**Ref: Response to request for review “Power generation from coking waste heat utilization project at Taiyuan Yingxian Coking & Chemicals Co., Ltd in Shanxi, China” with the Reference Number 1718**

28 July 2008

**Figure 1: Detailed Project Implementation Timeline**

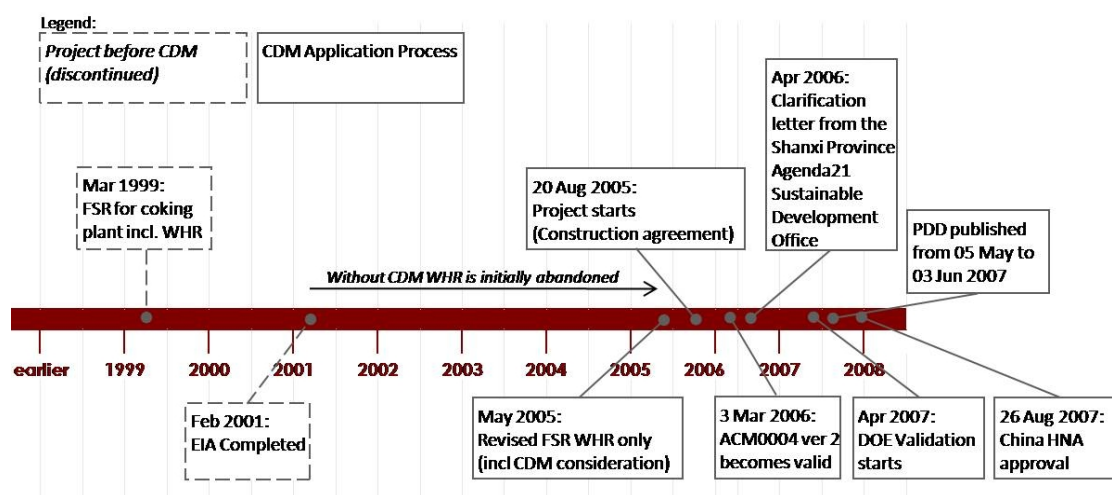
*"The DOE is requested to provide explanation for the delay in submitting the project*

for validation to show that CDM revenues were considered essential in the decision to invest in the project activity. The response should provide a detailed timeline of project implementation with relevant, preferably third-party evidence.”

A detailed timeline of the project implementation is provided in **Figure 1**. This timeline has been validated by the DOE.

During initial development of the coking facility a feasibility study was undertaken in 1999 to determine the feasibility of a waste heat recovery plant at the coking facility. Ultimately it was decided by the project owner not to proceed with the waste heat recovery plant at this time as it was not considered a financially attractive investment. In 2005 the project owner learned of CDM and reconsidered its decision, commissioning a new feasibility study in 2005 which considered the potential benefit of CDM.

The project owner seriously considered CDM revenues for its investment decision in May 2005, basing the decision on the revised FSR. A clarification letter from the Shanxi Province Agenda21 Sustainable Development Office (under the Provincial Development and Reform Committee) dated April 2006 confirmed that the project had started the CDM application process. This letter has been validated by the DOE and is referred to in the project’s validation report.<sup>9</sup>
